GFA AD 587

GFA AIRWORTHINESS DIRECTIVE

SUBJECT: Checking of the crankcase of Rotax 912 and 914 engines.

CHECKING OF THE CRANKCASE

Bild / Fig. 1

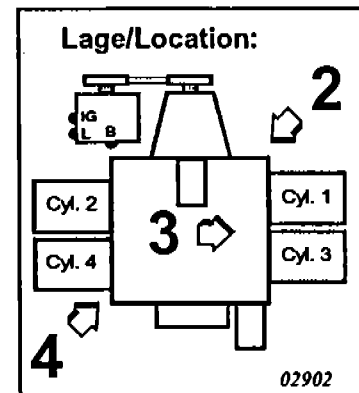
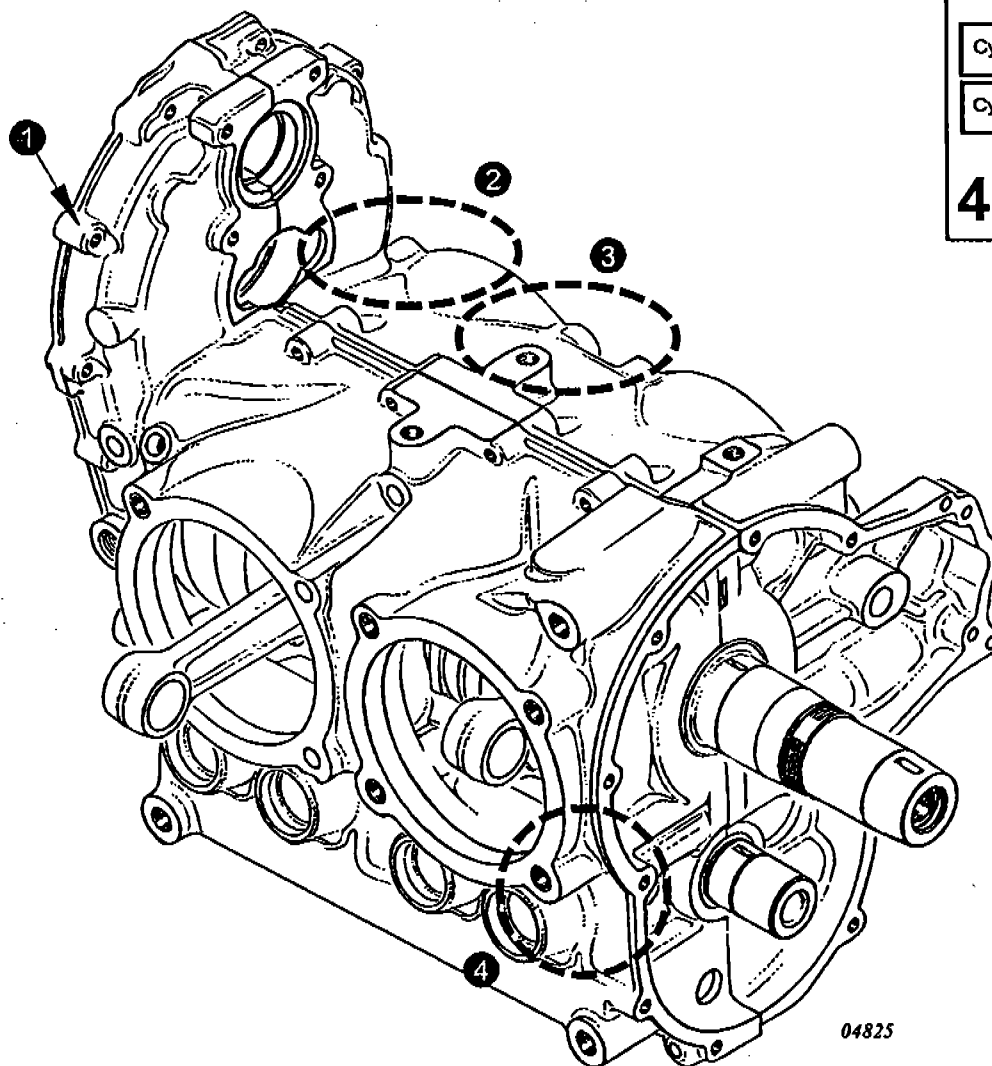
- Visually inspect the crankcase (1) and engine suspension for cracks in accordance with the relevant Maintenance Manual.

◆ **NOTE:** Scrutinize the crankcase for cracks especially in the area of cylinder 1 upper side (2), between cylinder 1 and 3 upper side (3) and cylinder 4 lower side (4). See fig. 1.

For those engines using the ROTAX_® cooling air baffle. Visually inspect for oil leaks in area (2) and (3). If leaks are found, then further investigation to determine the cause of the oil leak is required. If the exact origin of the leak can not be determined i.e. governor, then removal of the cooling air baffle may be required.

- If cracks are detected the nearest ROTAX_® Authorized Distributor (see also our official ROTAX-Web-Site: www.rotax-aircraft-engines.com) has to be informed and if necessary the engines has to be removed from aircraft and must be returned to a ROTAX_® Authorized Distributor.
